ADDENDUM NO: 3

PROJECT: Hamilton Heights High School Phase 2 Projects

PROJECT NO: 2023060

DATE: 03/05/2024

DRAWING TITLE:
ADMINISTRATION
FIRST FLOOR
PLAN -
LIGHTING

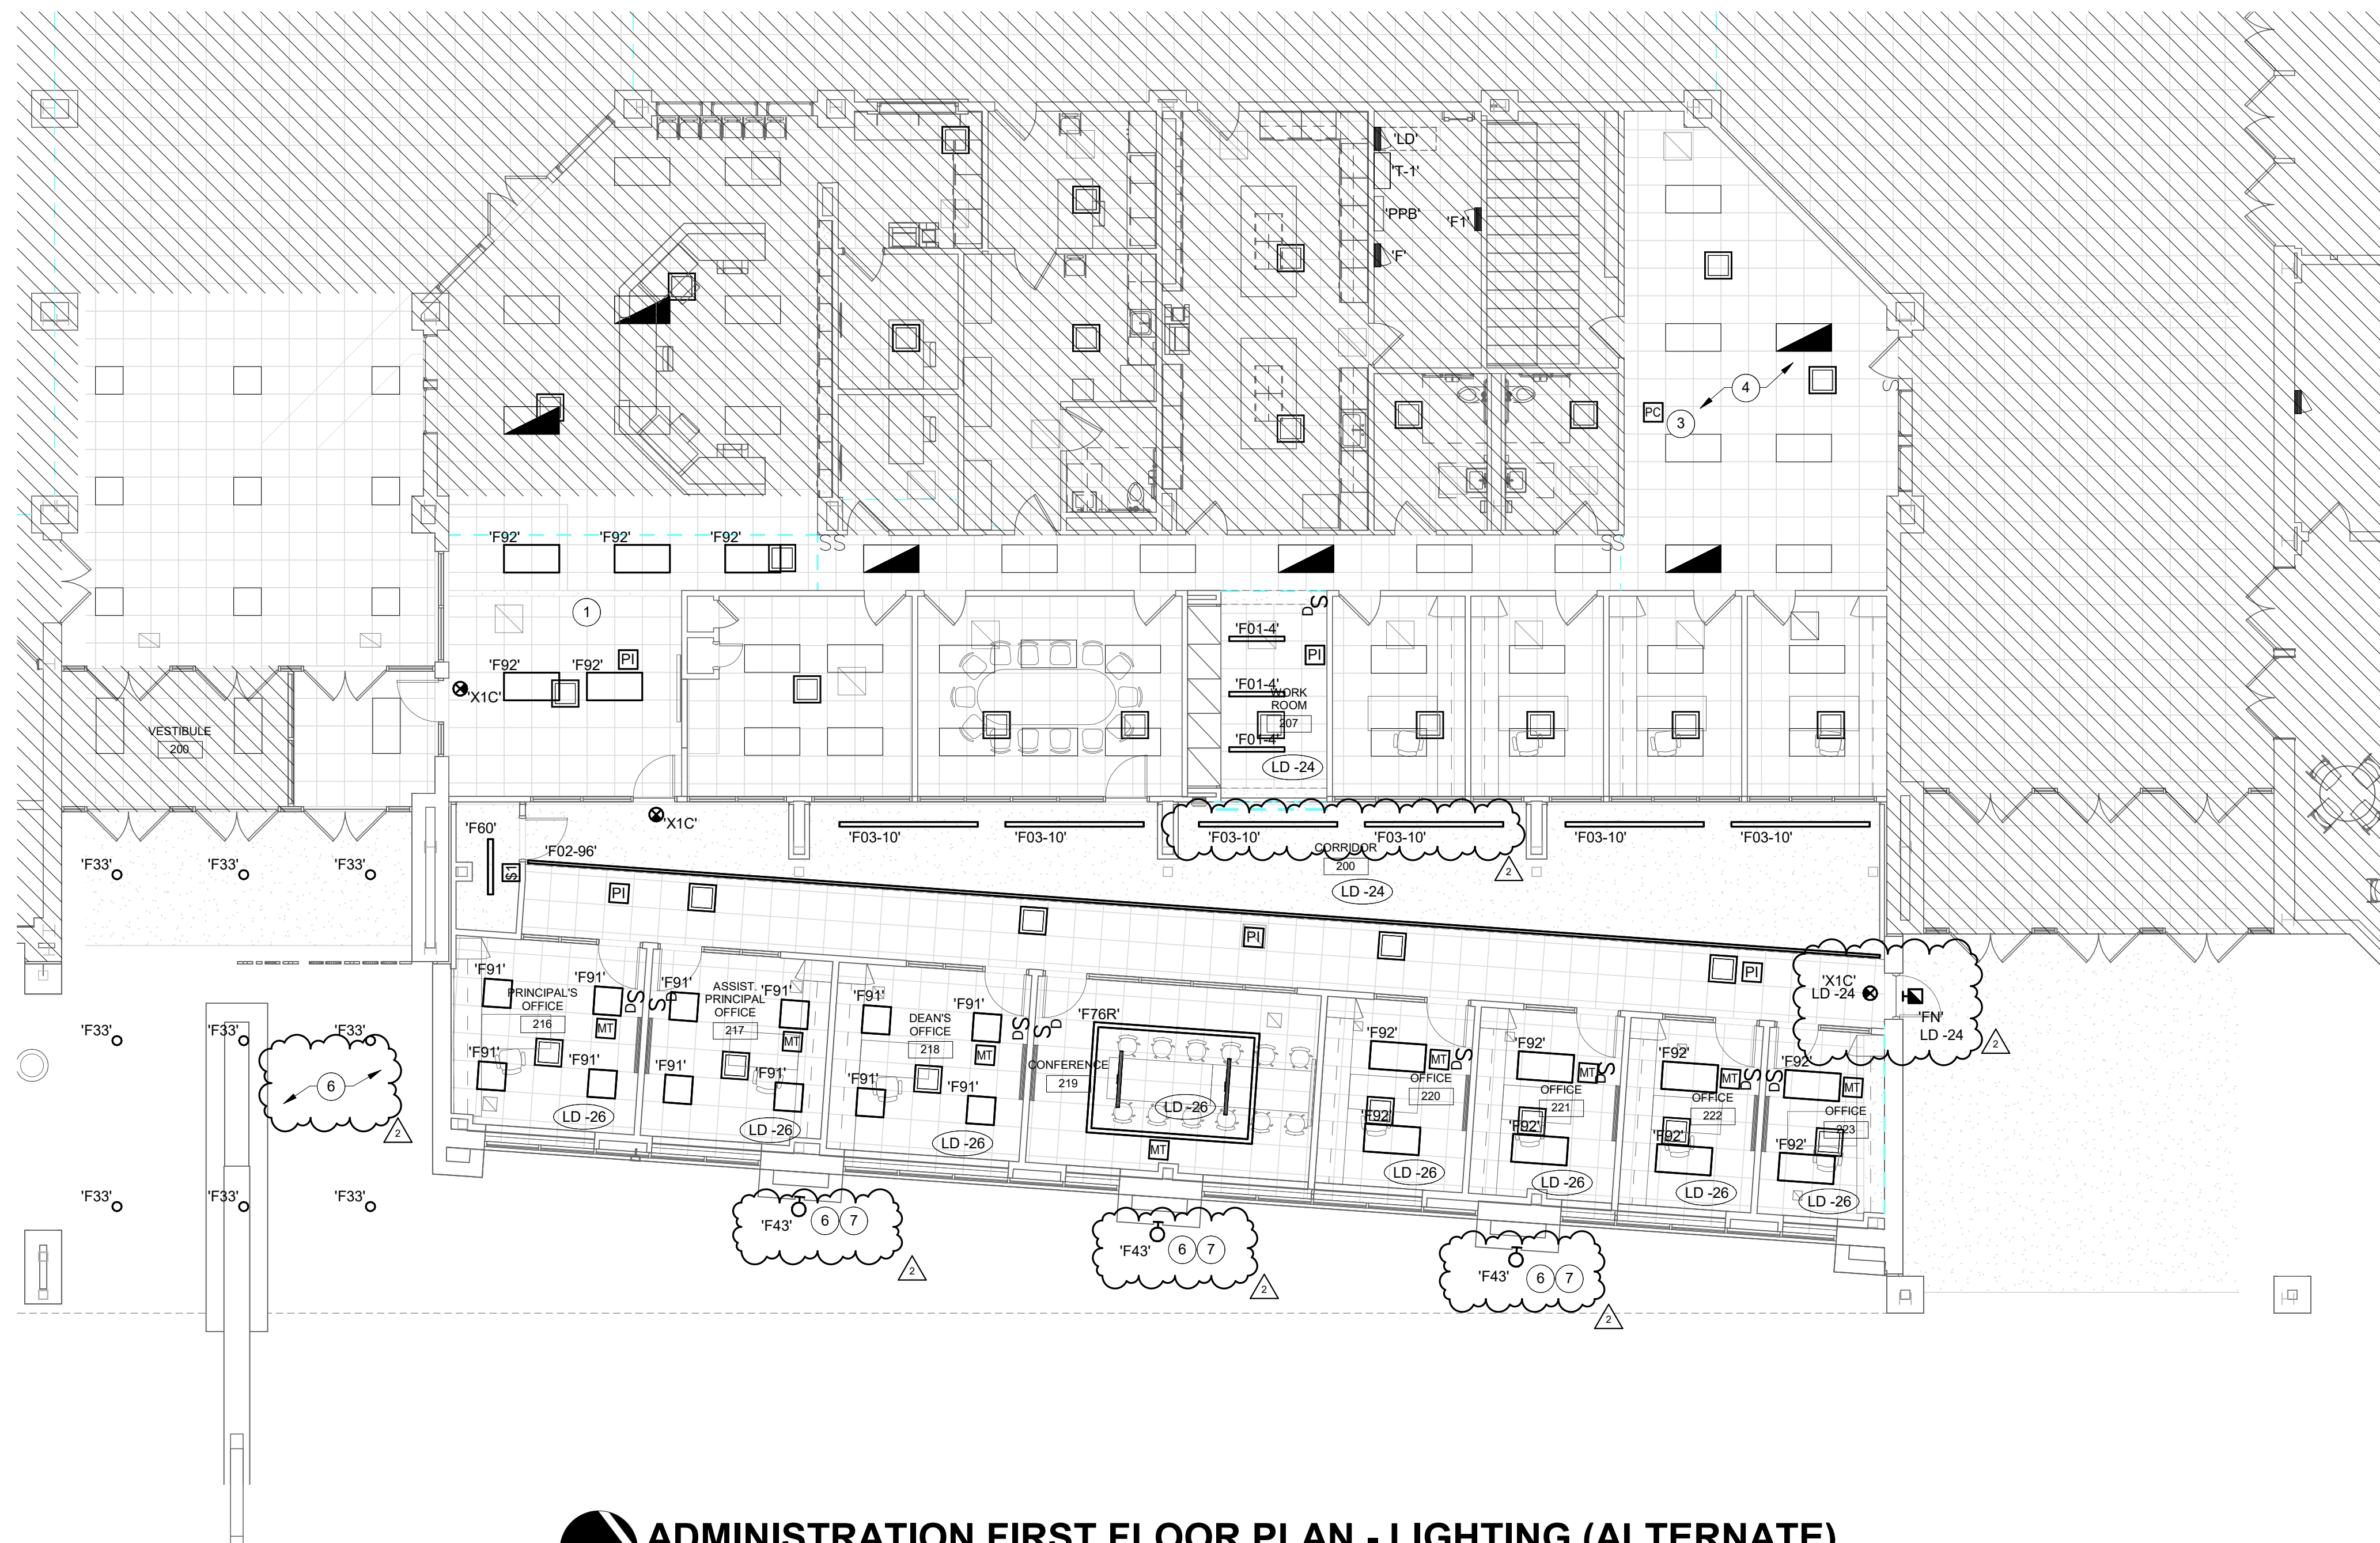
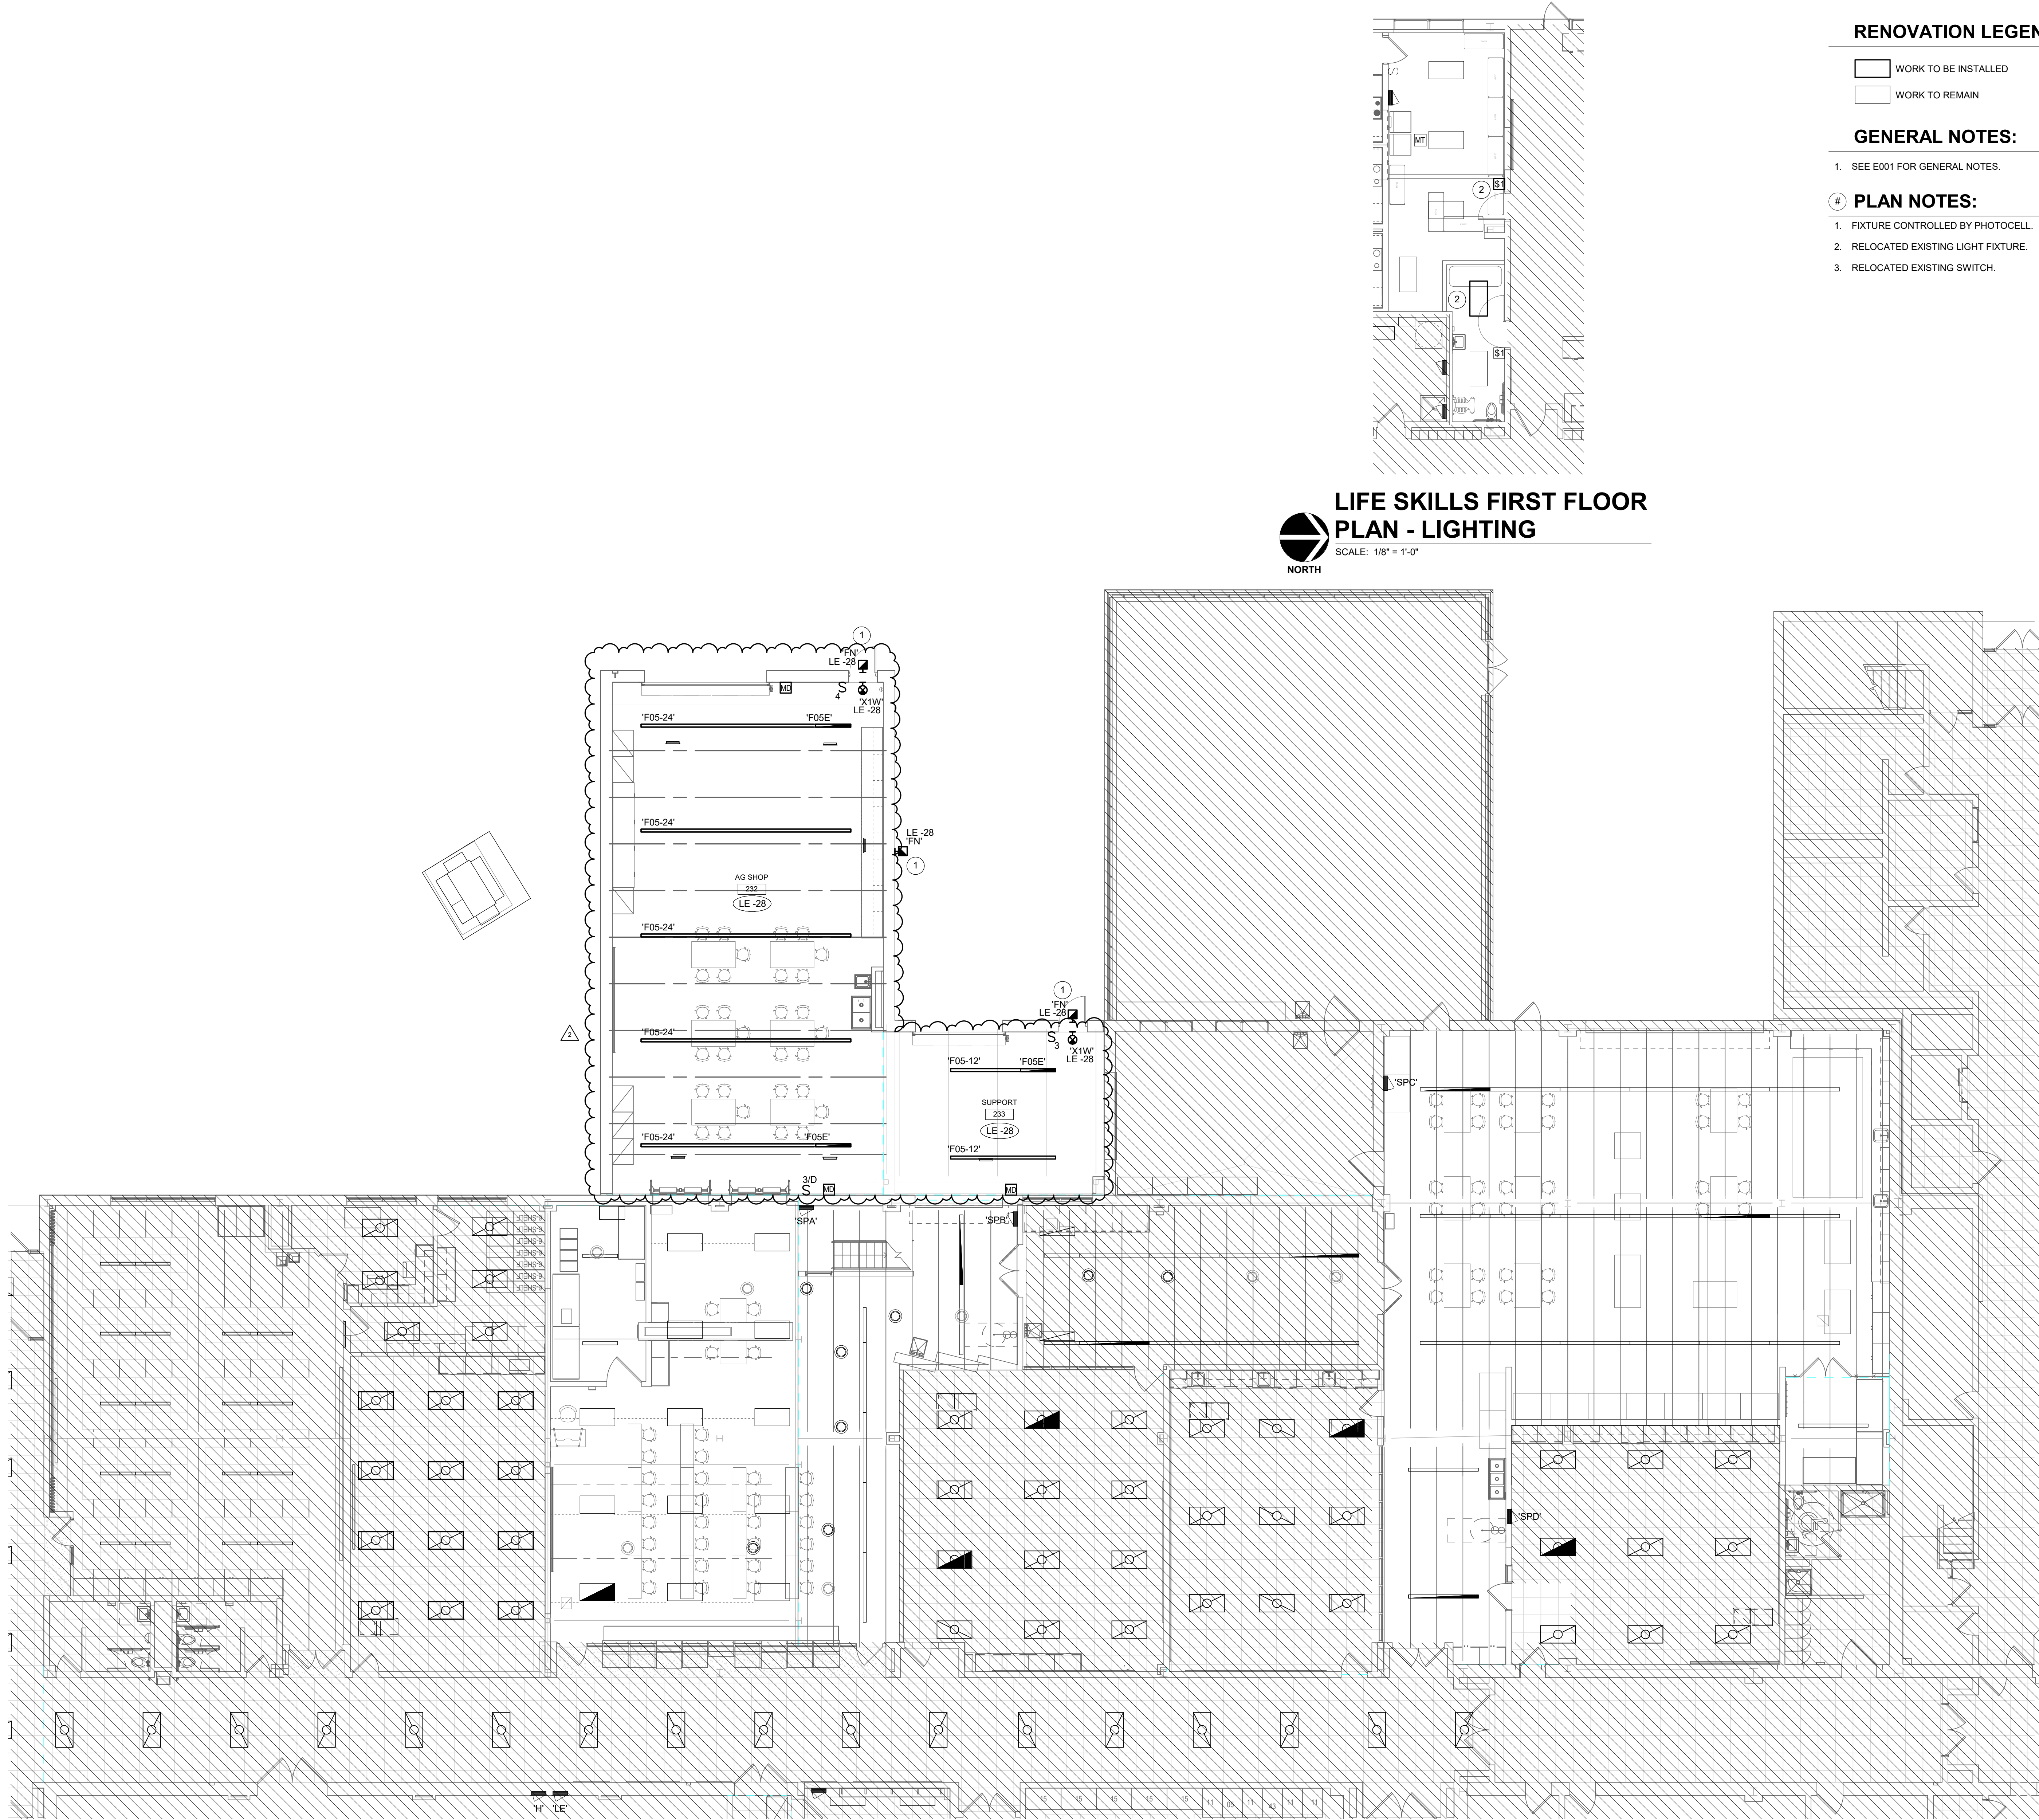
3.15 E201 – ADMINISTRATION FIRST FLOOR PLAN – LIGHTING

- A. Add Plan Notes as indicated in attached Drawing E201
- B. Reissue drawing in its entirety revising lighting

TICKET BOOTH PLAN - LIGHTING
SCALE: 1/8" = 1'-0"
NORTH

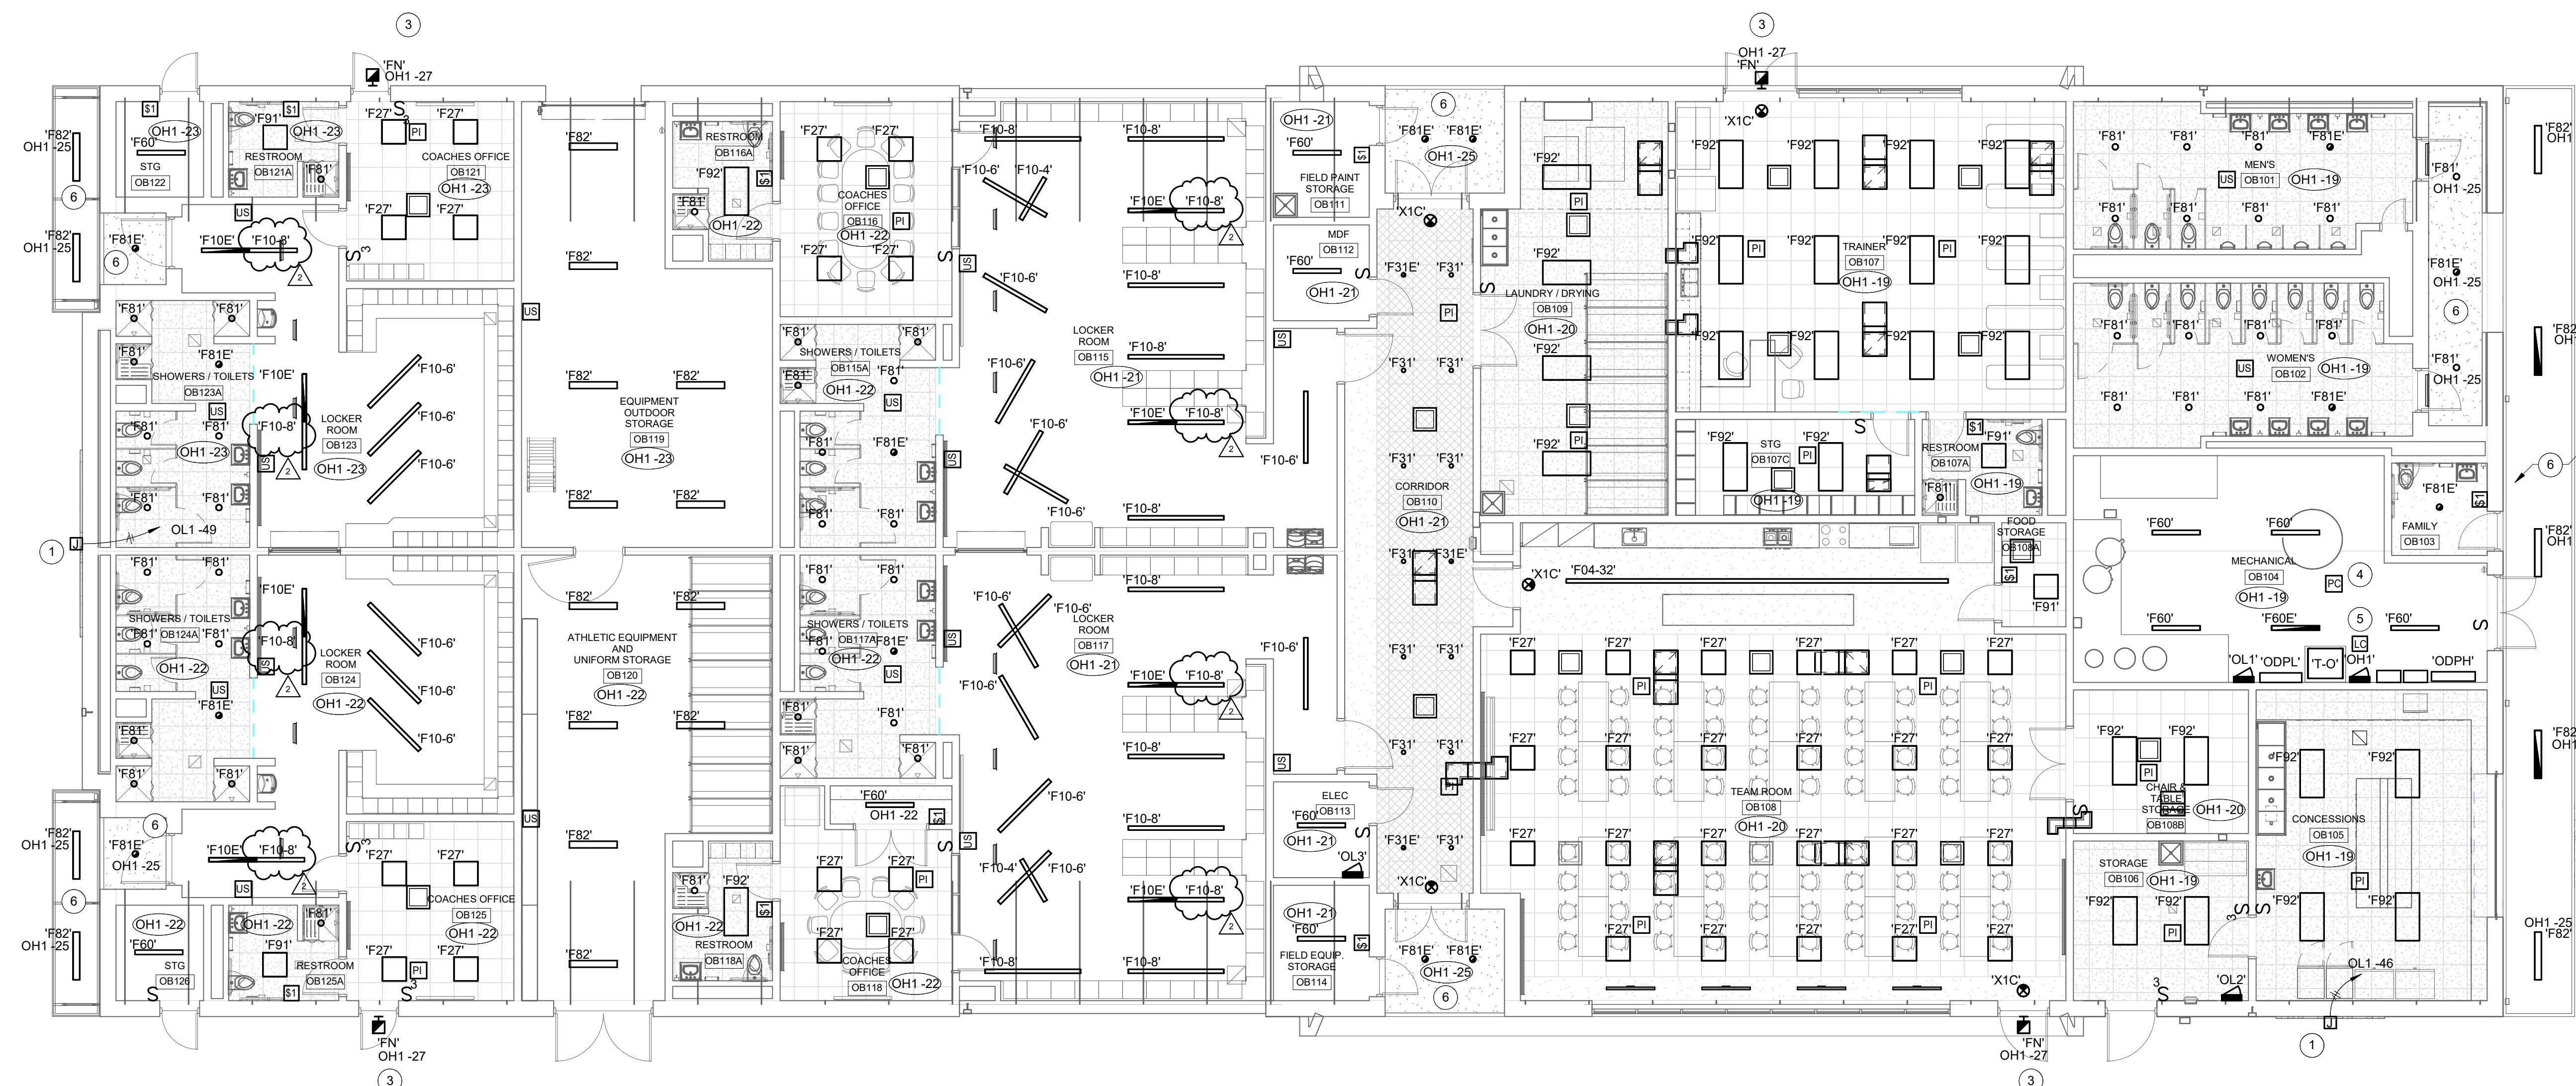
3.17 E203 – OUTBUILDING FLOOR PLANS – LIGHTING

- A. Update Fixture Types as indicated on attached Drawing E203.
